Addendum No. 4

Project: St. Patrick Catholic Church
Bid Set #3
6111 Morrill Avenue
Lincoln NE, 68507

Date Issued: June 3, 2014

DOCUMENT 009213 – ADDENDA – NO. 2

Addendum 02
AAD-1.0
6-3-14
Sheet A112, Detail H1

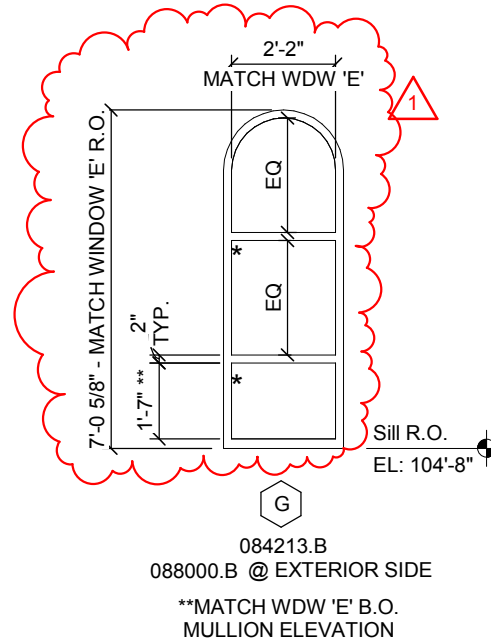
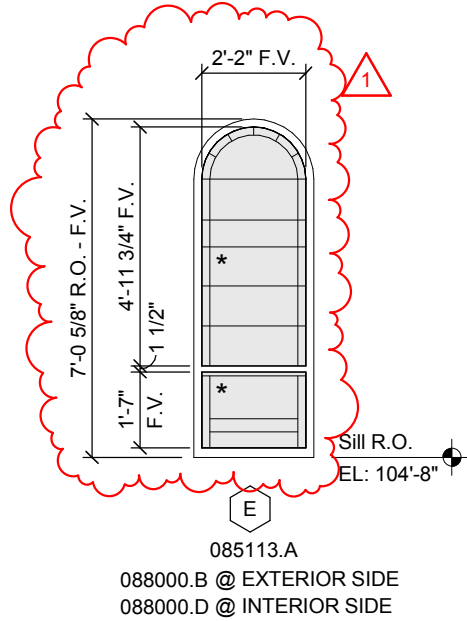
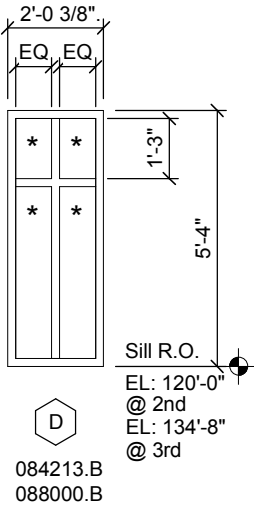
- B. Sheet A112 – Exterior Aluminum Window Types and Wall Types (not reissued).
 - 1. Revised existing refurbished stained glass window 'E'. Window 'G' also revised to match size of window 'E'. See attached Architectural Addendum Drawing AAD-1.0.

Addendum 02
 AAD-2.0
 6-3-14
 Sheet A401, Detail H4

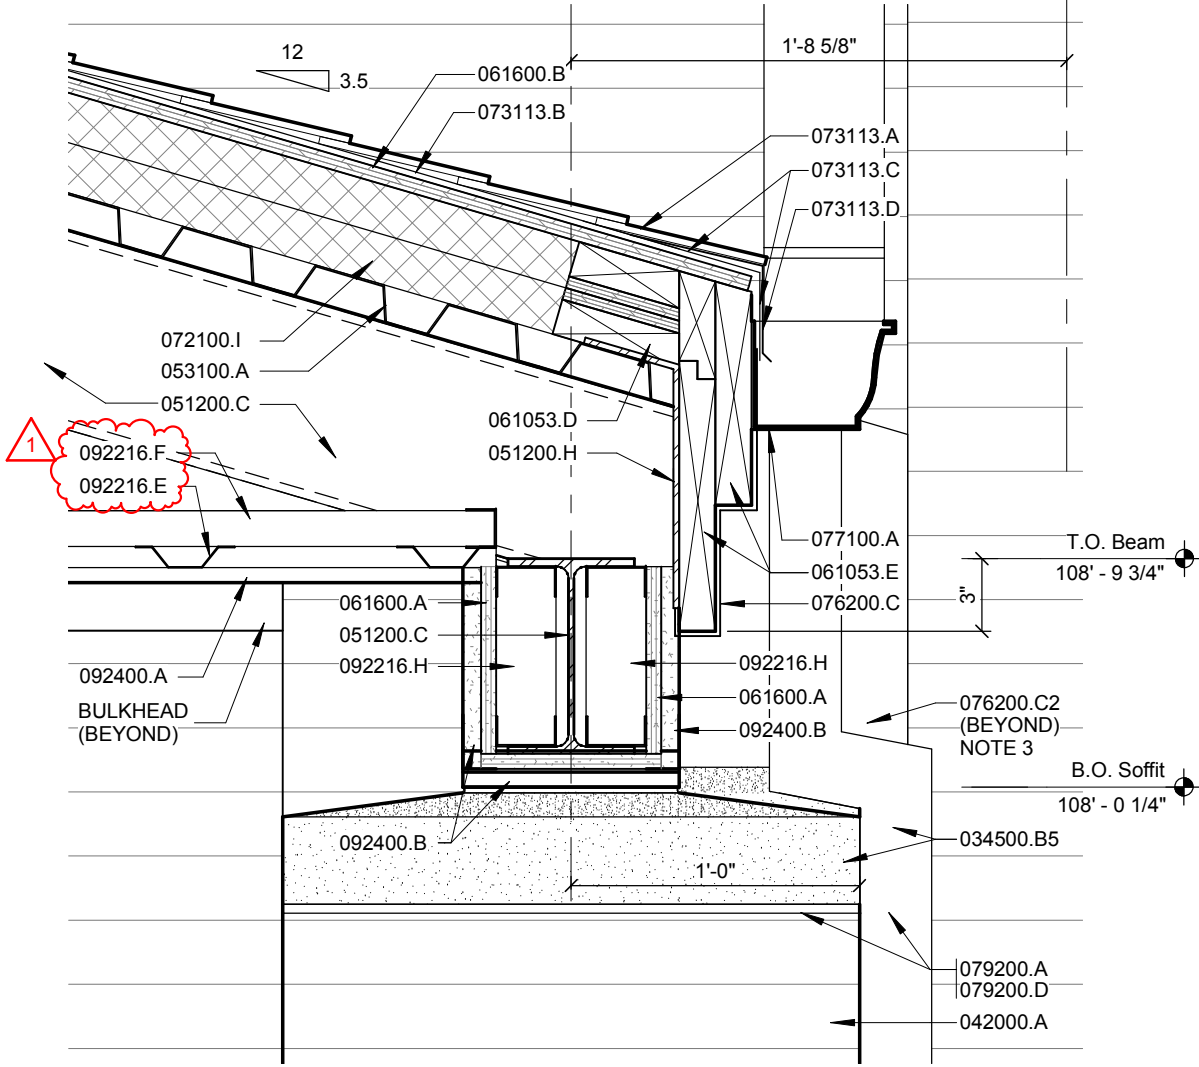
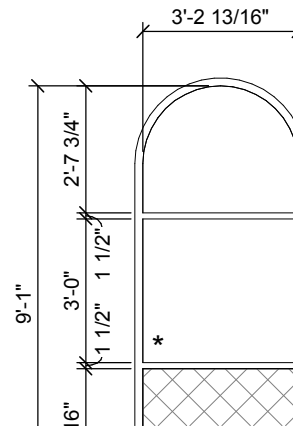
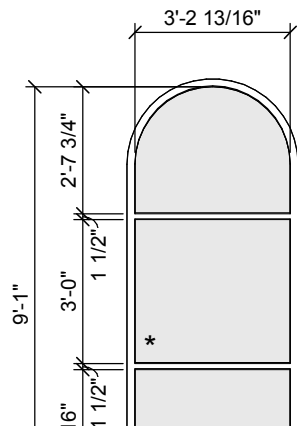
- C. Sheet A401 – Enlarged Details (not reissued).
 - 1. The exterior soffit will be metal lath that is fastened (wired) to the hat channels which are supported by 1 ½” carrying channels. The plaster is applied to the metal lath. See attached Architectural Addendum Drawing AAD-2.0.

- 2. Provide bid alternate for Direct Applied Finish System (DFS) for the horizontal surfaces; parts around the beam are to stay as plaster. Alternate to be submitted for approval prior to bid.

Addendum 02
AAD-3.0
6-3-14
Sheet A403, Detail H7

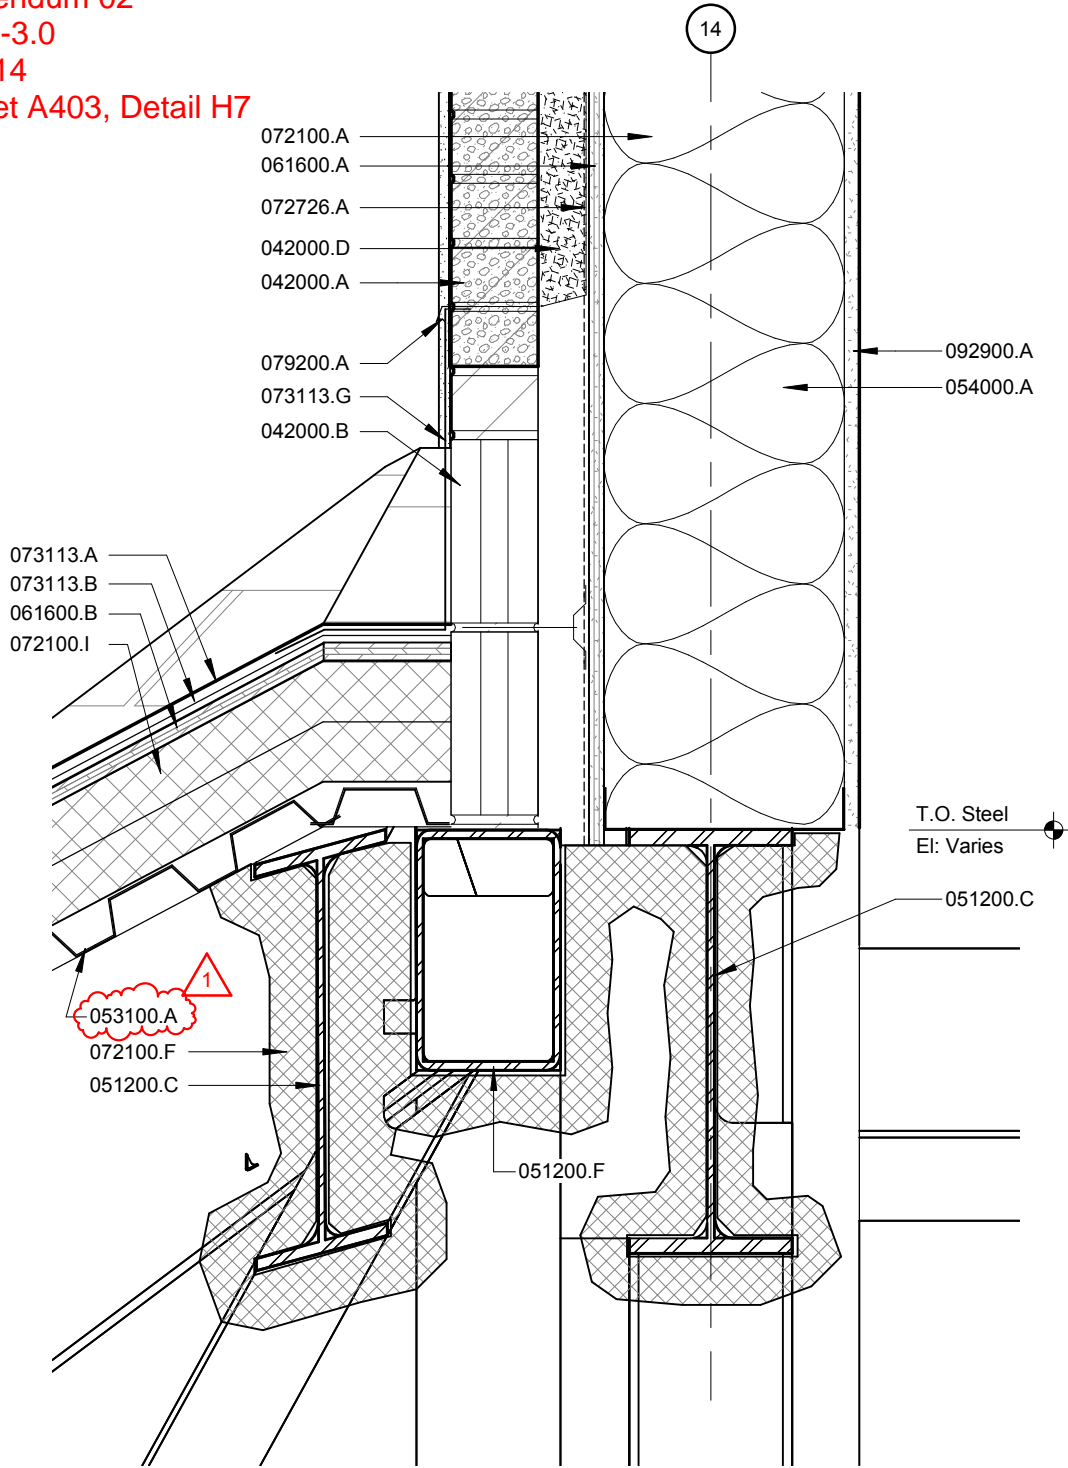
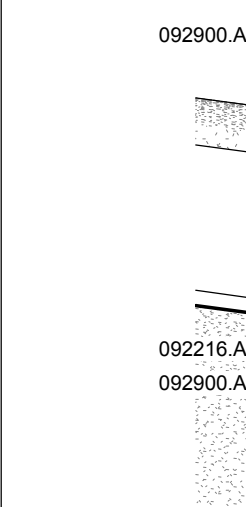
- D. Sheet A403 – Enlarged Details (not reissued).
 - 1. Metal roof deck above Sanctuary to be 1 ½” in lieu of 3” as per structural Roof Framing Plan, Note 7, Sheet S2.6. See attached Architectural Addendum Drawing AAD-3.0.

Addendum 02
AAD-4.0
6-3-14
Sheet A600, Detail K2

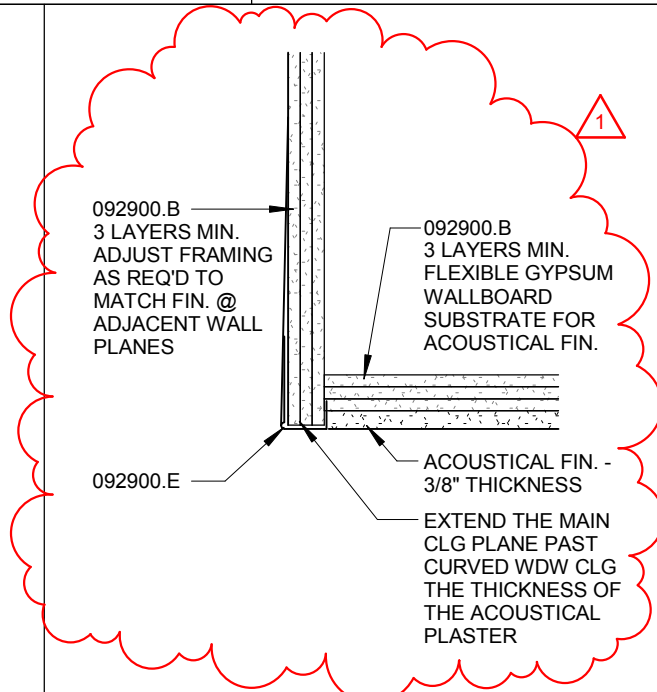
- E. Sheet A600 – Interior Details (issued with future Interiors Package).
 - 1. Section detail of finished drywall to acoustical treatment condition. See attached Architectural Addendum Drawing AAD-4.0.
